ZONING SITE PLAN FOR:
URZAR TRUCKING

PETITION NO: Z-38

Z-38

ZONING COMMENTS:

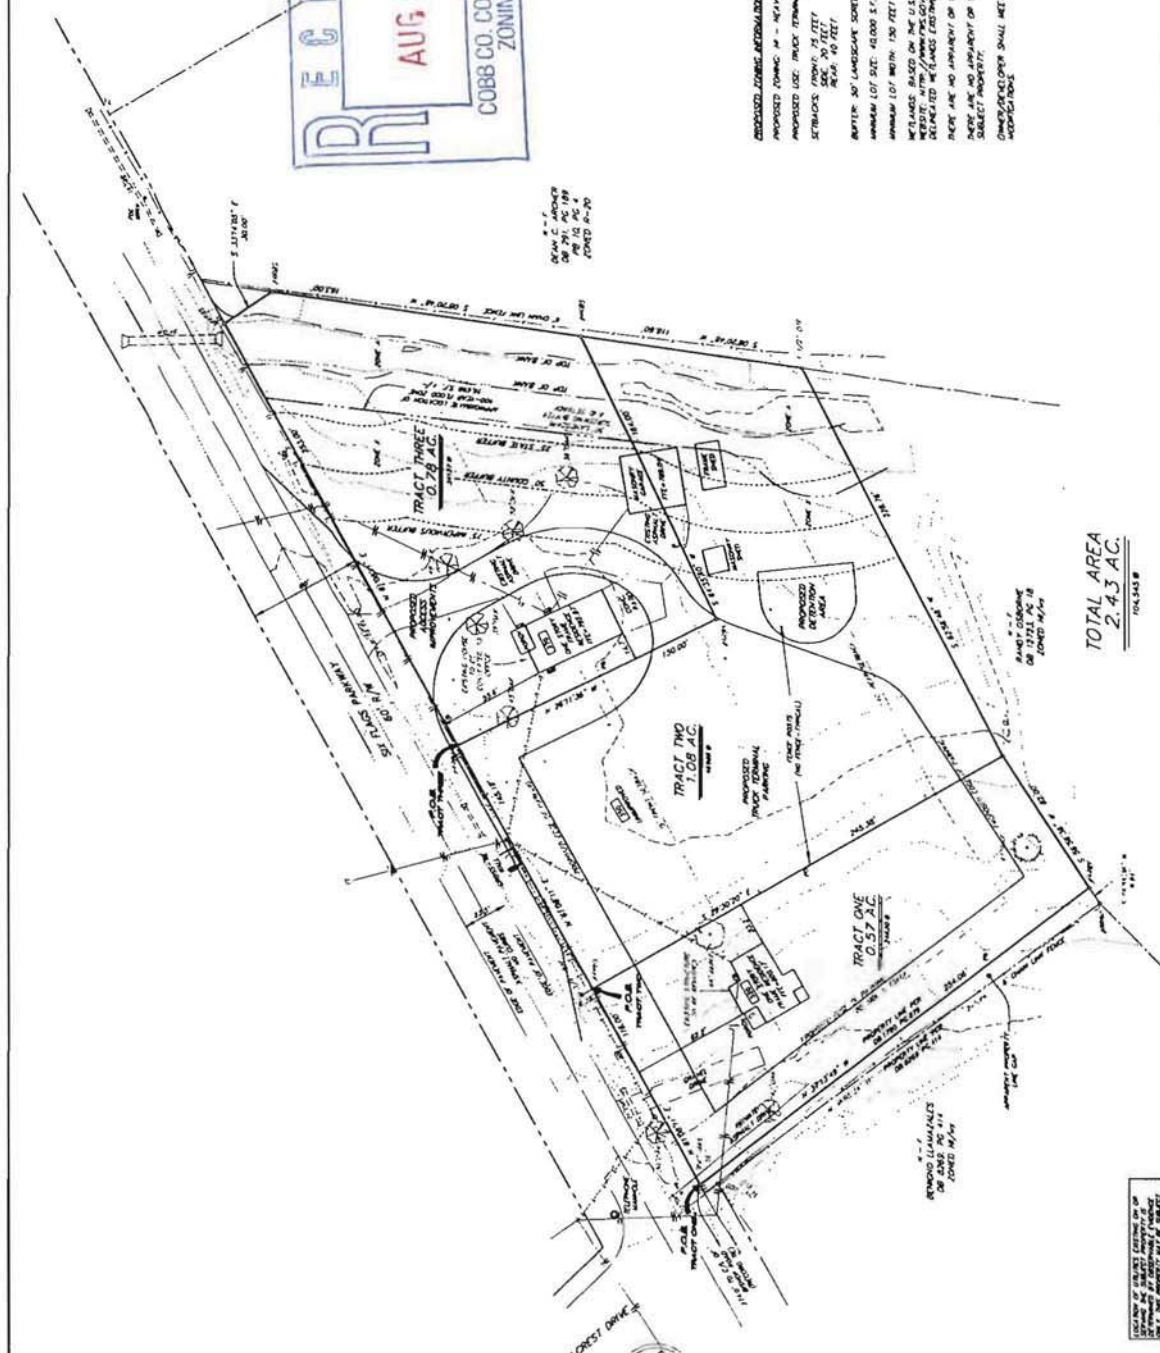
- Provide comprehensive hydrology/stormwater controls to include development of out parcels.
- Submit all proposed site improvements to Plan Review.
- Any **spring activity** uncovered must be addressed by a qualified geotechnical engineer (PE).
- Structural fill _____ must be placed under the direction of a qualified registered Georgia geotechnical engineer (PE).
- Existing facility.
- Project must comply with the Water Quality requirements of the CWA-NPDES-NPS Permit and County Water Quality Ordinance.
- Water Quality/Quantity contributions of the existing lake/pond on site must be continued as baseline conditions into proposed project.
- Calculate and provide % impervious of project site.
- Revisit design; reduce pavement area to reduce runoff and pollution.

- No Stormwater controls shown _____
- Copy of survey is not current – Additional comments may be forthcoming when current site conditions are exposed.
- No site improvements showing on exhibit.

1. A commercial truck repair facility is considered a stormwater quality “hot-spot” due to the potential for discharge of contaminated runoff. The installation of an oil/water separation device will be required to treat runoff from this site. The development of a written stormwater pollution prevention plan (SWPPP) will also be required for the site.

Six Flags Parkway is classified as a major collector and according to the available information the existing right-of-way does not meet the minimum requirements for this classification.

Recommend one access to Six Flags Parkway.

Recommend curb, gutter, and sidewalk along Six Flags Parkway frontage.

Recommend a deceleration lane on Six Flags Parkway for the entrance.

- Site plan received by the Zoning Division on August 22, 2012, with the District Commissioner approving minor modifications;
- Water and Sewer comments and recommendations;
- Stormwater Management comments and recommendations;
- DOT comments and recommendations;
- Owner/developer to enter into a Development Agreement pursuant to O.C.G.A. §36-71-13 for dedication of system improvements to mitigate traffic concerns.
